MONROE STREET ELEVATION FROM APPROVED PUD PUD - November 30, 2009 by Torti Gallas and Partners

PROPOSED

CUA South Campus - Block E

Bay Studies CUA South Campus - Block E

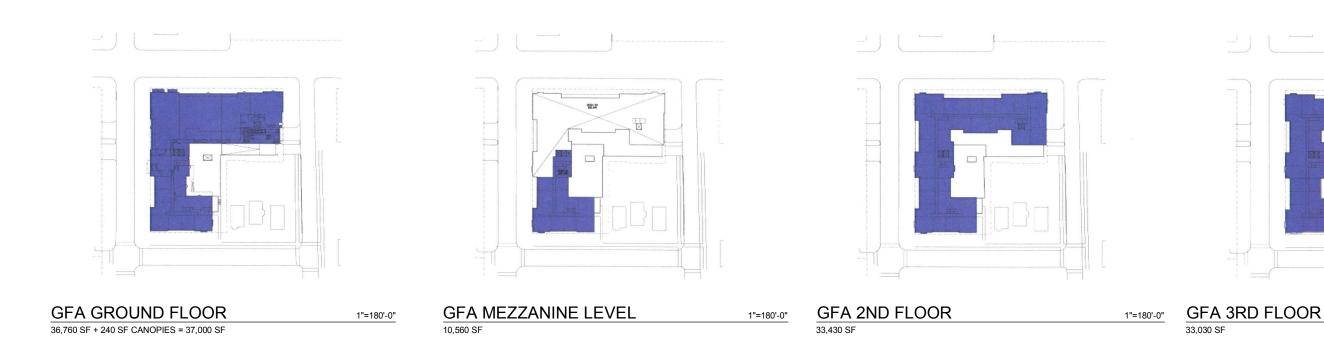
REFINE WINDOW, DORMER

COORDINATE WITH INTERNAL DWELING

WIDER WINDOWS

BRICK PANEL

OMIT SMALL VERTICAL WINDOWS AT PIERS AND REPLACE WITH DECORATIVE

UNIT CONFIGURATIONS
